**Anchor QEA Technical Memorandum: Engineering Peer Review 60%  
Submittal**

**Re: Port of Poulsbo Breakwater Replacement  
Engineering Peer Review  
60% Submittal**

# PORT OF POULSBO POULSBO, WASHINGTON BREAKWATER REPLACEMENT

60% BREAKWATER DESIGN DRAWINGS

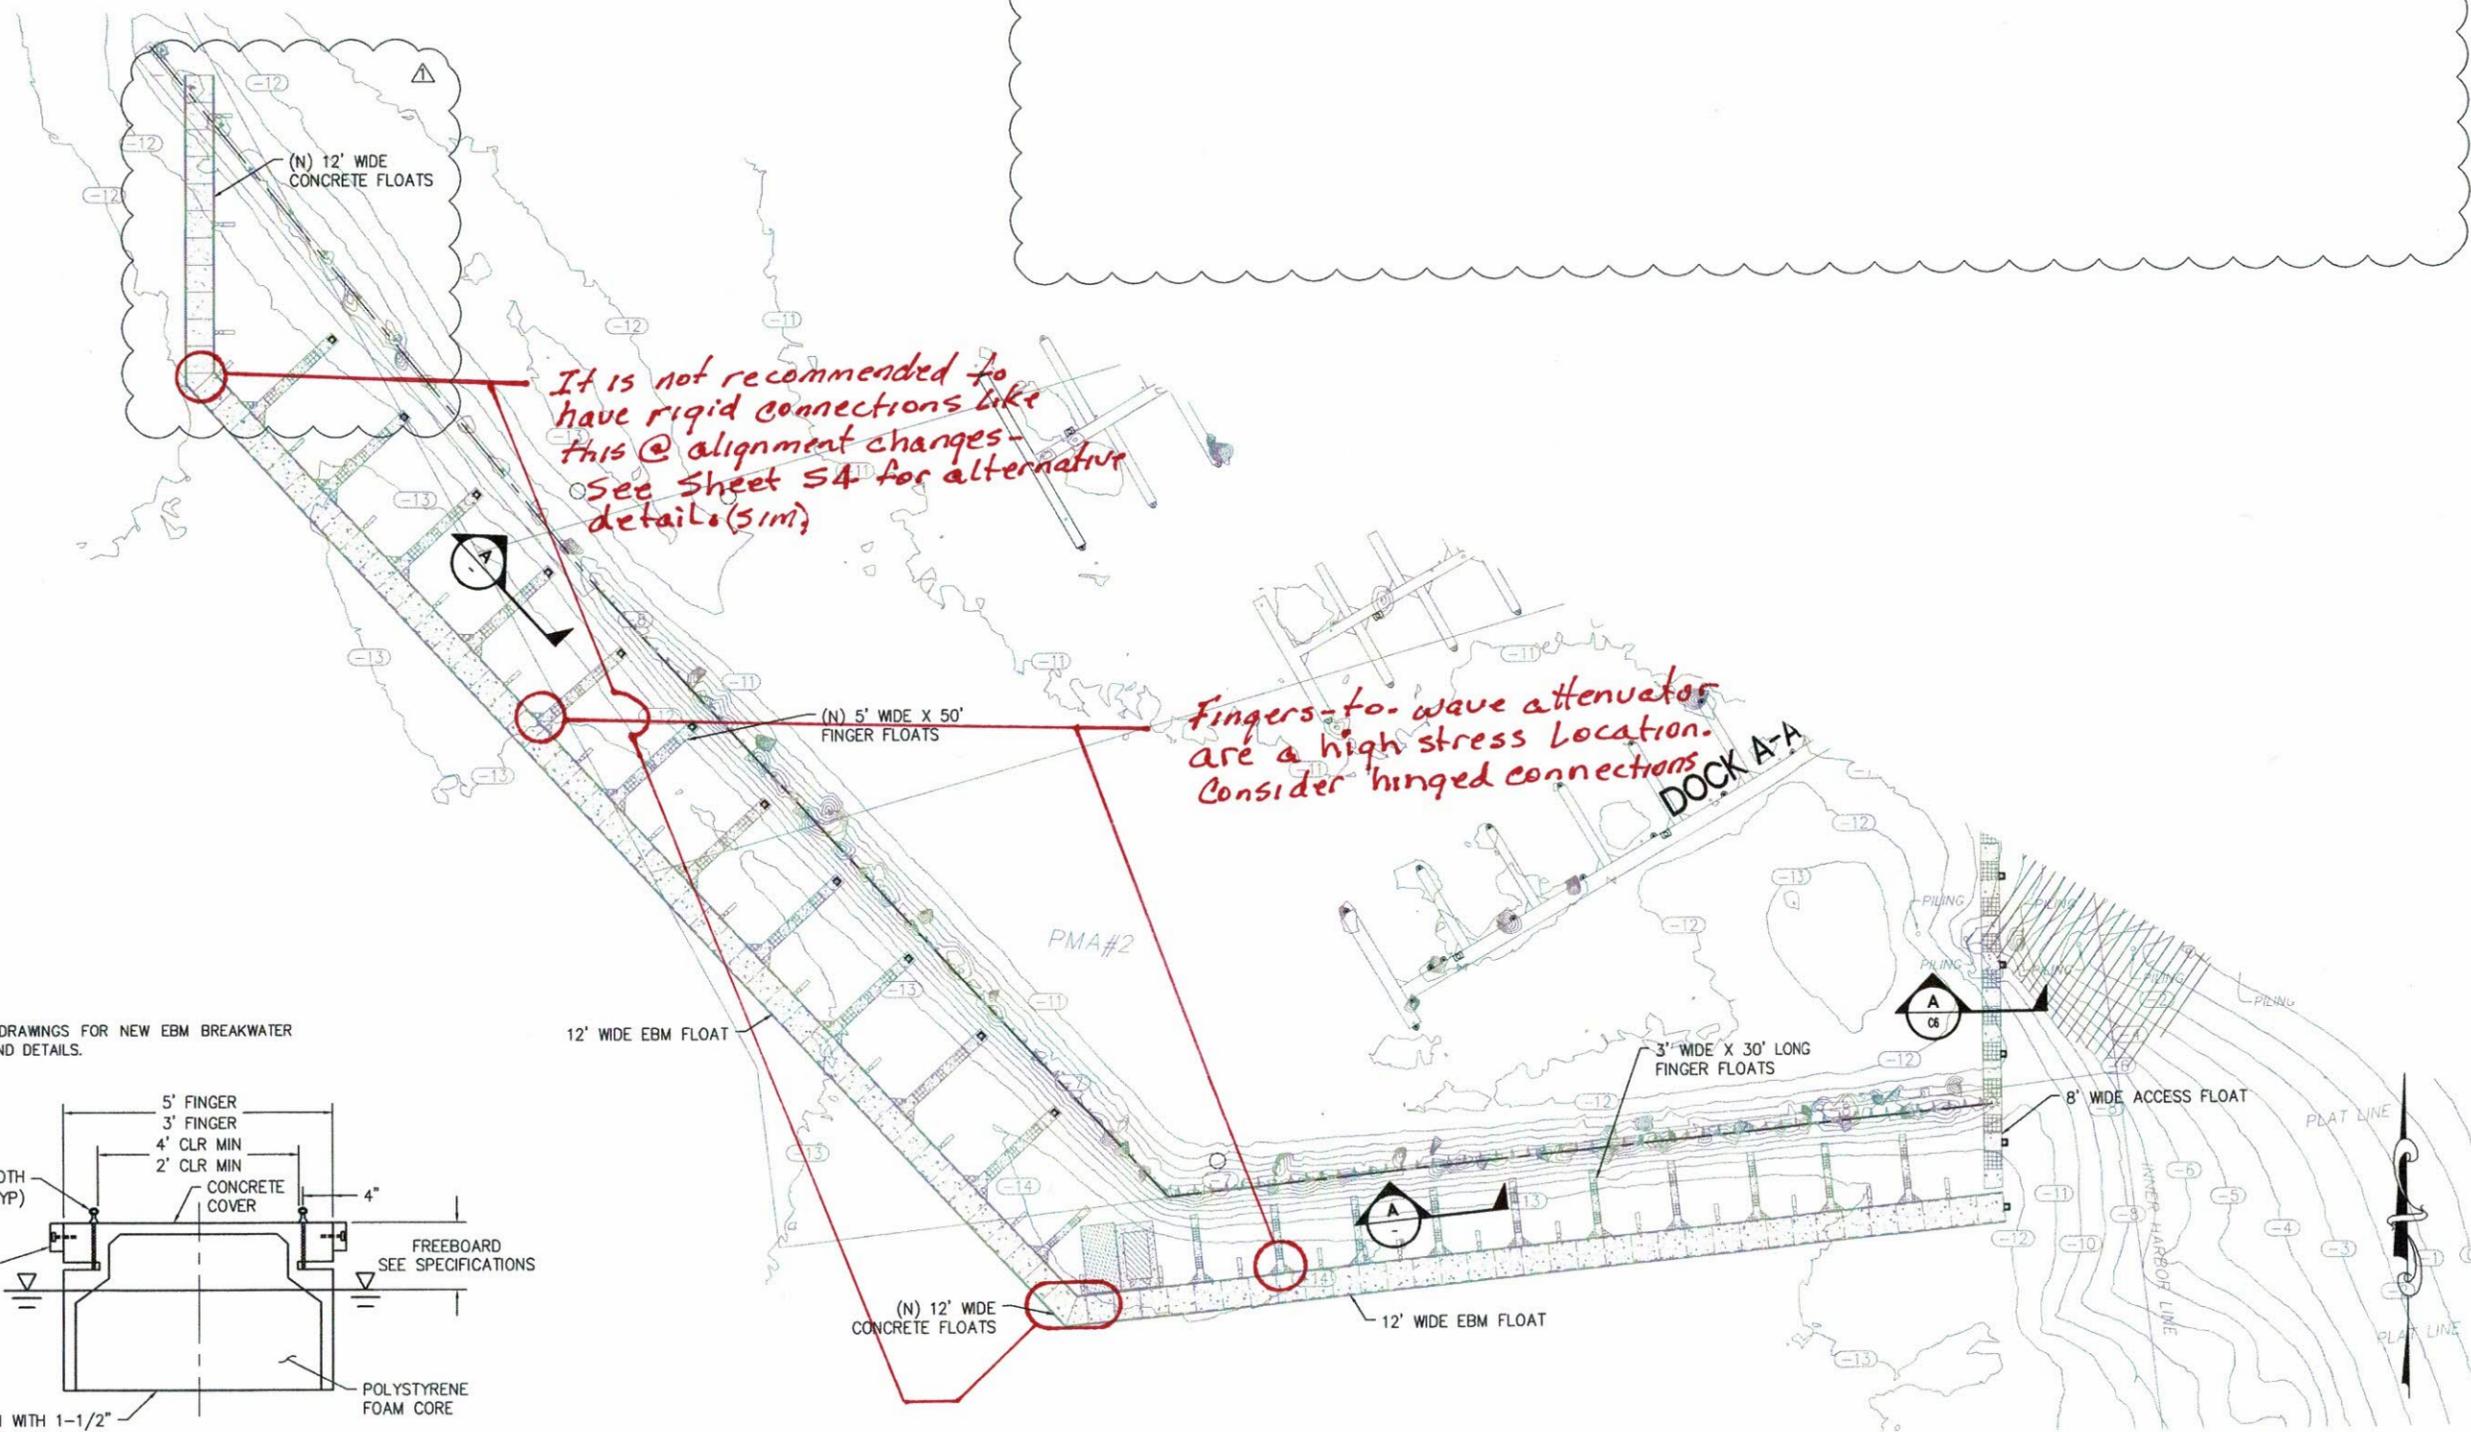
*Rigid connections between attenuator alignments is not recommended - See com'ts on C10, sim.*

*For fingers attached to attenuator, see C7*

*Consider relocating these floating structures elsewhere; i.e. not on a wave attenuator.*

*Rigid connections between alignments is not recommended - See com'ts on C10, sim*

*For fingers attached to the attenuator, see C7*

*For pile @ end of attenuator, see C8/S1*

**FLOAT - PLAN**

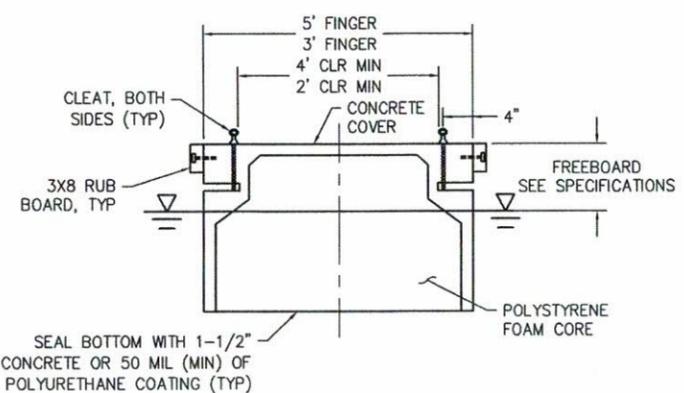
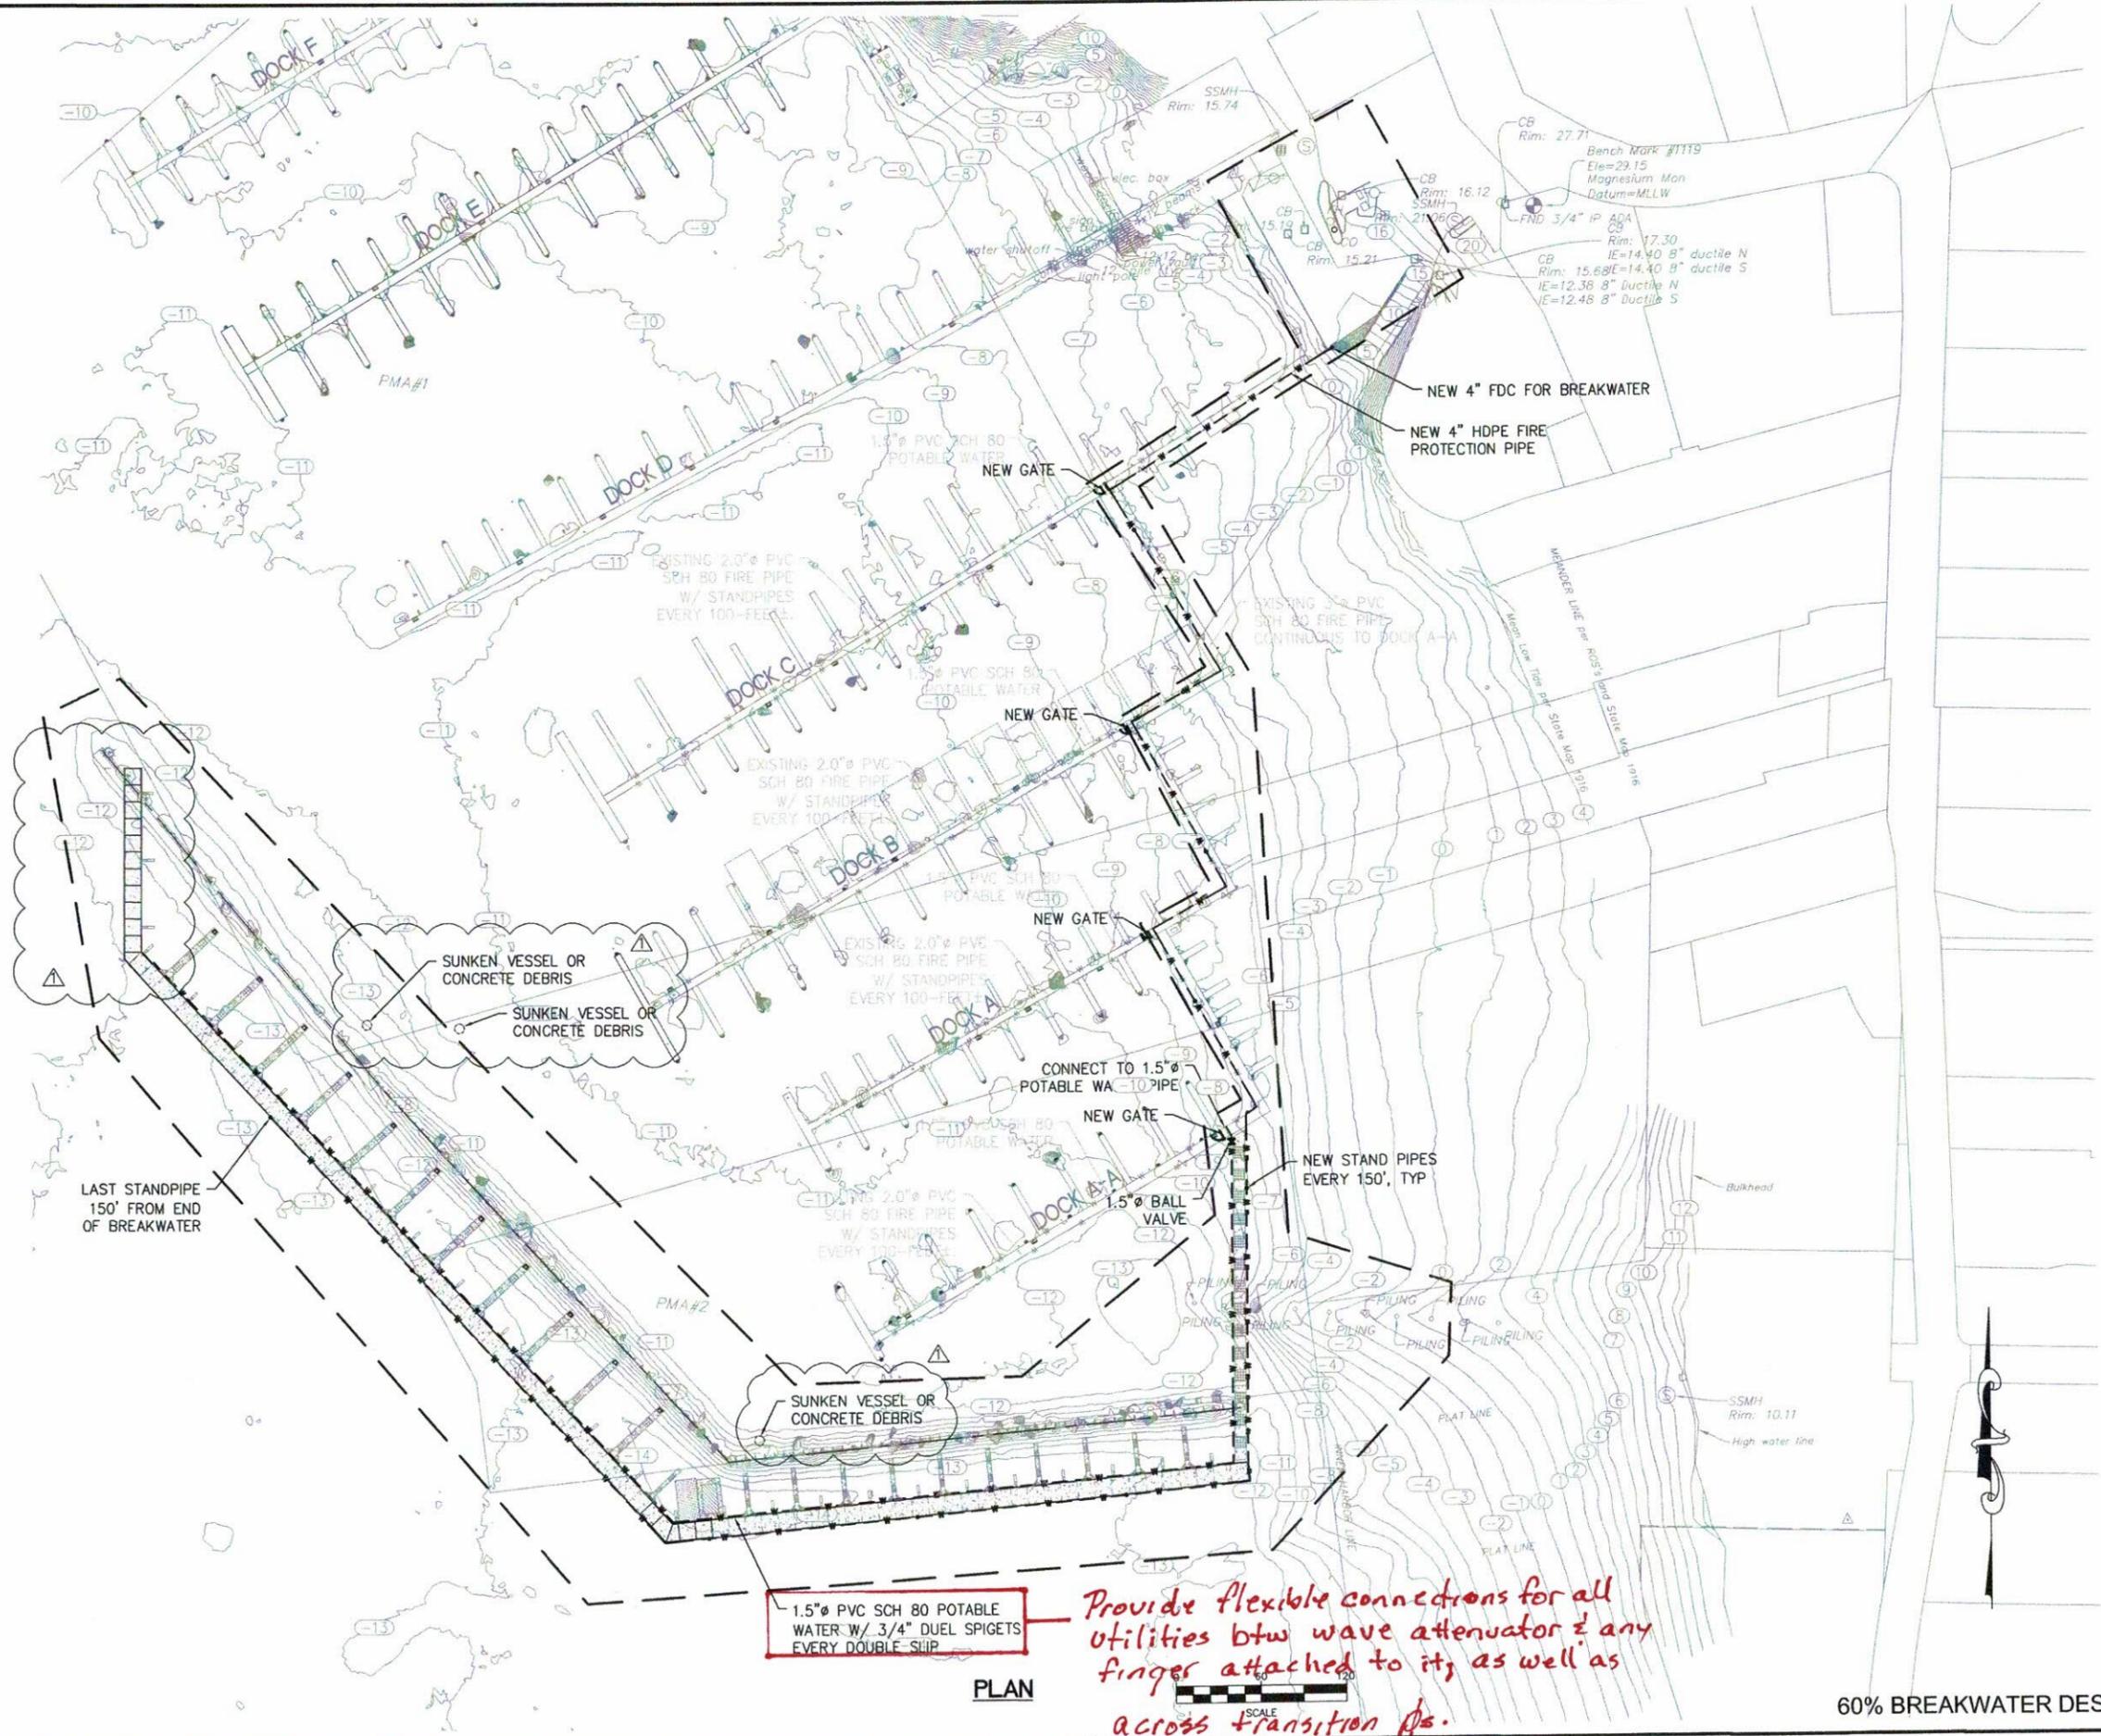
4. C7 – Float Plan
  - a. Locations are noted where we recommend flexibility in the connections between various floating elements.
5. C8 – Cleat Details
  - a. It is not recommended that cleats be provided on the outside face of a wave attenuator, as boats berthed in this location could get damaged and become an insurance liability. A specific wale size is noted in Detail 5. Is this a requirement or minimum size desired by the Port? If not, it should be left up to the design/builder based on the loading criteria.

- b. Finger-to-attenuator connection
    - i. It is recommended that the finger-to-attenuator connections be hinged rather than fixed. Because the attenuator will react to incoming wave action much differently than the attached fingers, these connections could become highly stressed. A hinge connection would relieve these stresses and provide a longer finger life if done properly.

*It is not recommended to have rigid connections like this @ alignment changes - See Sheet S4 for alternative details (SIM)*

*Fingers-to-wave attenuator are a high stress location. Consider hinged connections*

POTABLE WATER & FIRE PROTECTION -  
PLAN

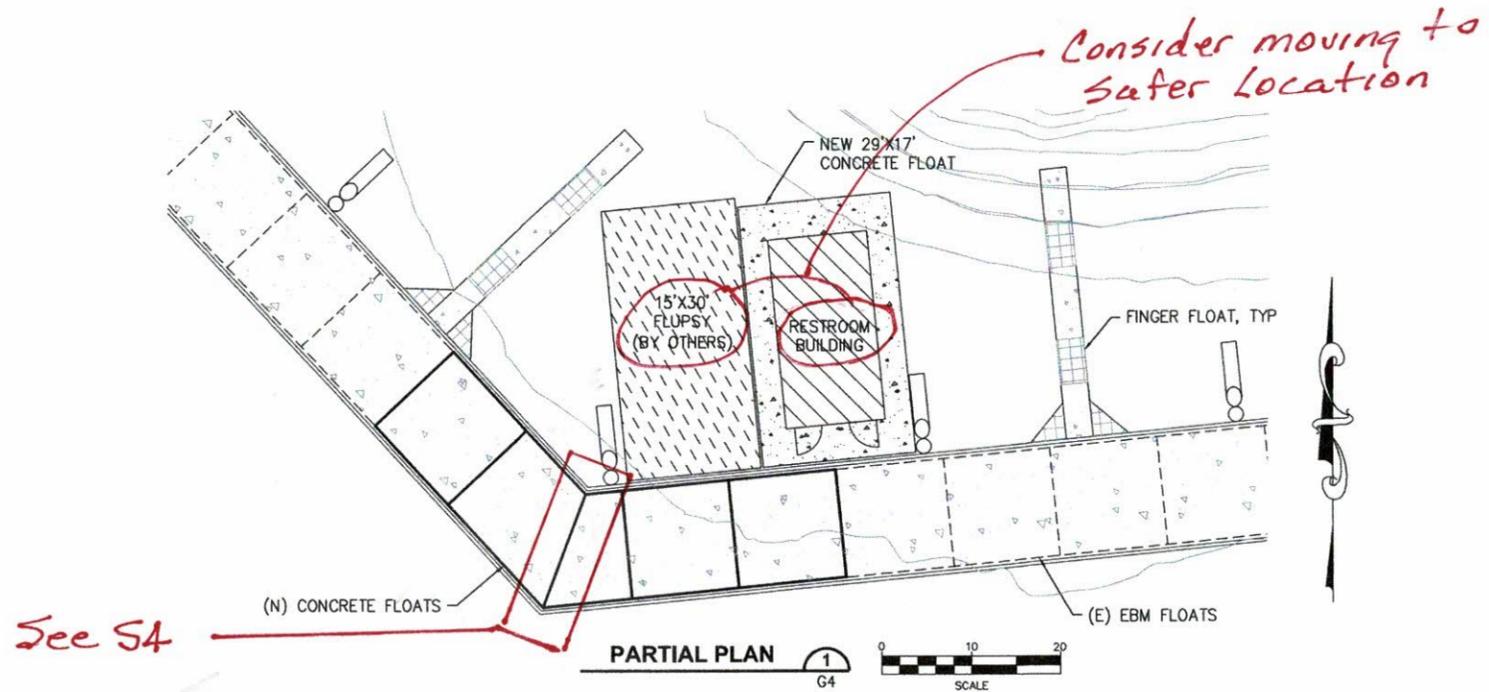
6. C9 – Potable Water and Fire Protection Plan
  - a. Provide details for the expansion loops for water and sewage lines in order to determine flexibility in the piping system to take extreme differential movements in the floating elements.

- b. Consider moving the restroom and FLUPSY float to a safer location within the marina due to potential extreme movements of the wave attenuator in relationship to the restroom

*Provide flexible connections for all utilities btw wave attenuator & any finger attached to it, as well as across transition pts.*

**TRANSITION RAMP ELEVATION (3)**

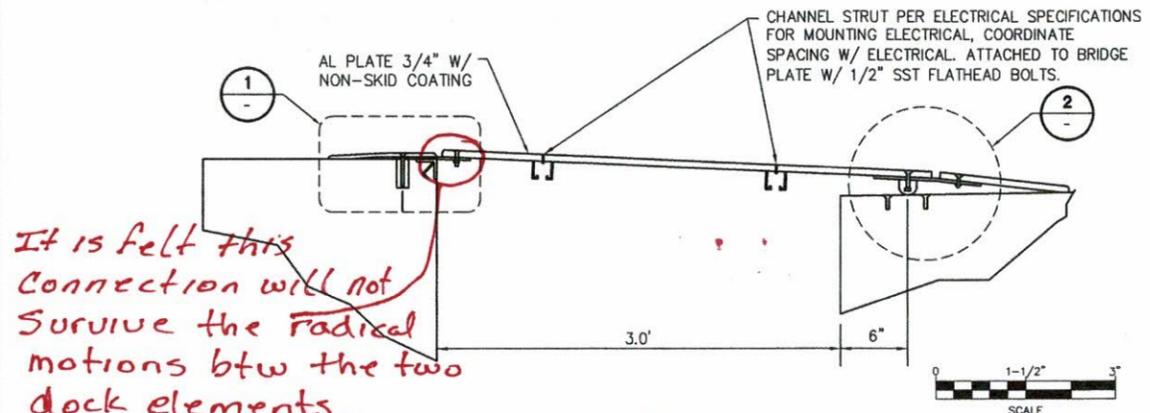
When the wave attenuator rotates, this sliding end will lift-off the float & will probably deform the plate or damage the (E) side. More degrees-of-freedom required.

**TYPICAL TRANSITION RAMP PLAN (4)**

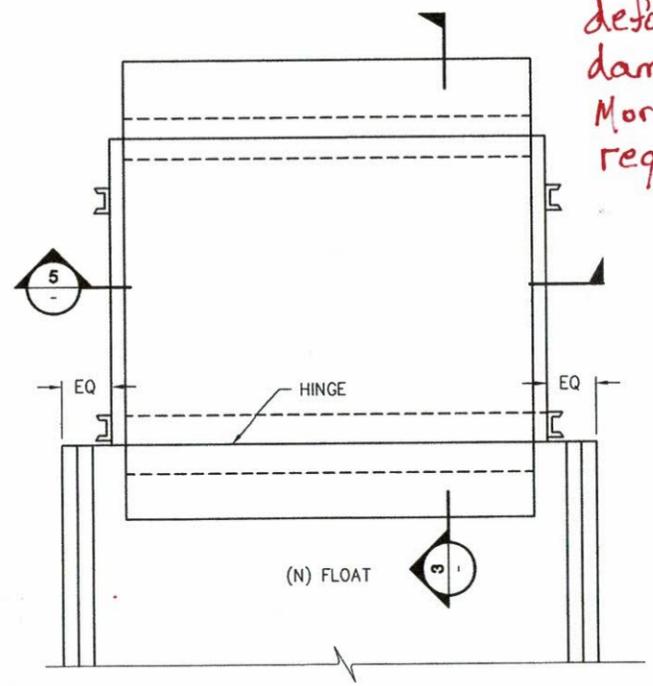
See SK-1 for an example of a transition plate with expanded degrees of freedom allowing for large dock movements.

Note: It may be wise to have different types of transition plates for the various locations due to geometry & differing predicted movements

**TRANSITION RAMP SECTION (5)**

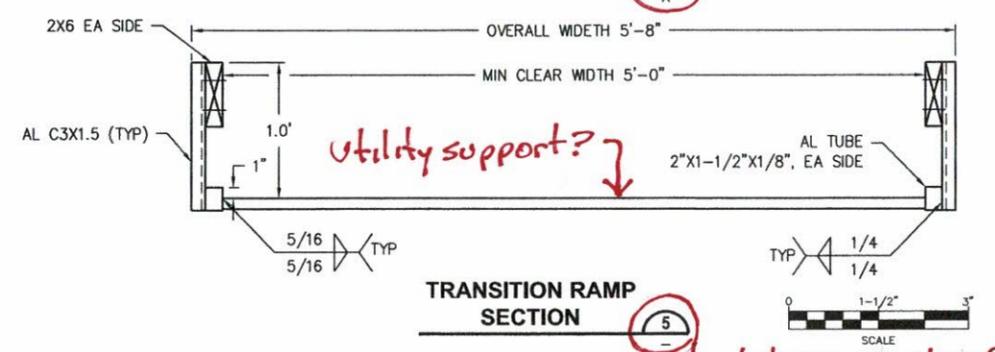
Where is the ramp plate in this detail?
